HORSHAM DISTRICT COUNCIL CONSULTATION

TO:	Horsham District Council – Planning Dept
LOCATION:	Phases 2 and 3 Land at Wellcross Farm Broadbridge Heath
DESCRIPTION:	Application for Approval of Details Reserved by Condition 2 (Construction Management Plan), ³ (borehole to meet Private Water Supplies), ⁴ (Private Water Supply Management Plan), ⁵ (finished floor levels and external ground levels) and 7 (underground services) to approved application DC/24/0205 Reserved matters application pursuant to condition 5 of outline planning permission DC/19/1897 for the provision of phases 2 and 3 of Land at Wellcross Farm to provide a continuing care retirement community with 94 units of accommodation (C2), with access, infrastructure, open space, landscaping and associated works including an onsite borehole water supply).
REFERENCE:	DISC/26/0012 & DISC/26/0013
RECOMMENDATION:	Advice / Modification / More information.
2nd response in Red	Advice / Modification / More information.

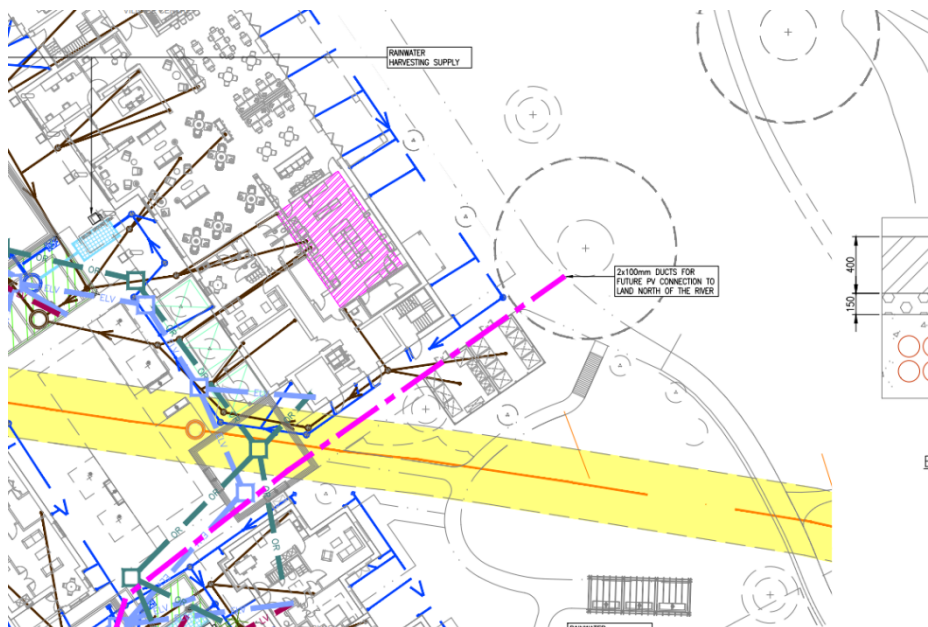
The RPA, of the unknown tree shown in the image above, taken from Electrical & Electrical Services Drawing No. 1163-ESD-XX-00-DR-XX-P2-1001, revision 2, still indicates that the ducts for the future PV connection to land north of the river fall within the tree's RPA. Please seek confirmation that the ducts will be removed and that the PV connection will not be sited within the RPA, or alternatively that trenchless installation methods will be used at a depth greater than 1.5 m below existing ground levels. Concerns addressed.

Accordingly, amendments should be sought to the route of the service runs to ensure that they do not encroach within the RPA of tree T31, and outside of the RPA, of the unknown tree in the above image taken from Electrical & Electrical Services Drawing No. 1163-ESD-XX-00-DR-XX-P2-1001. [Concerns addressed.](#)

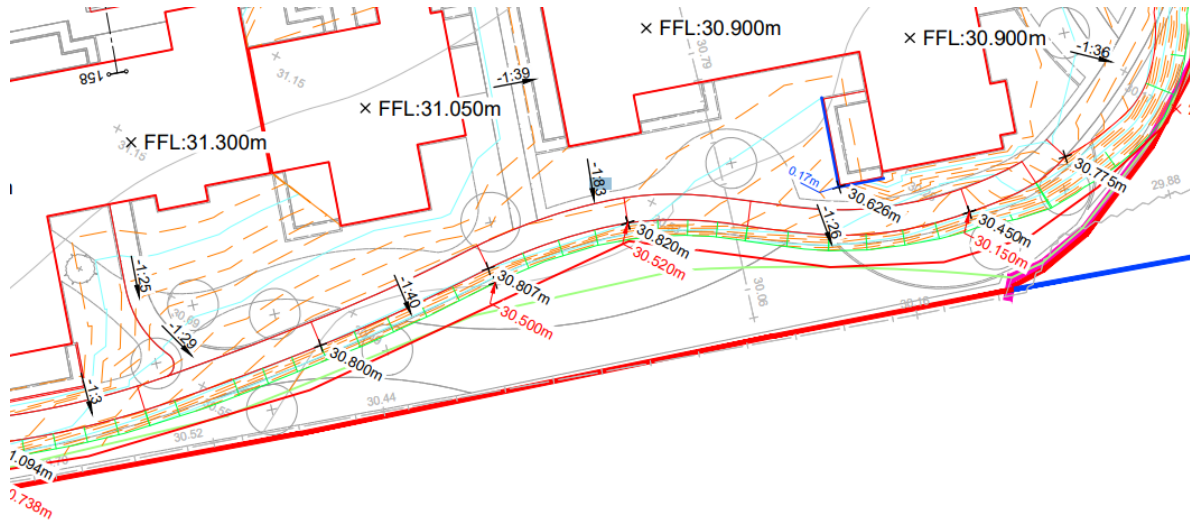
Further concerns are also raised in relation to the proposed landscaping works and associated land level changes in the area to the northwest of off-site trees T30 and T31, both oaks. Given the lack of detail on how the works would be completed without resulting in direct construction damage or indirect post-development harm, including root damage and soil compaction, these proposals are considered problematic. Please seek confirmation on the exact extent of the level changes and landscaping works within the RPA of T30, and T31. [Concerns addressed.](#)
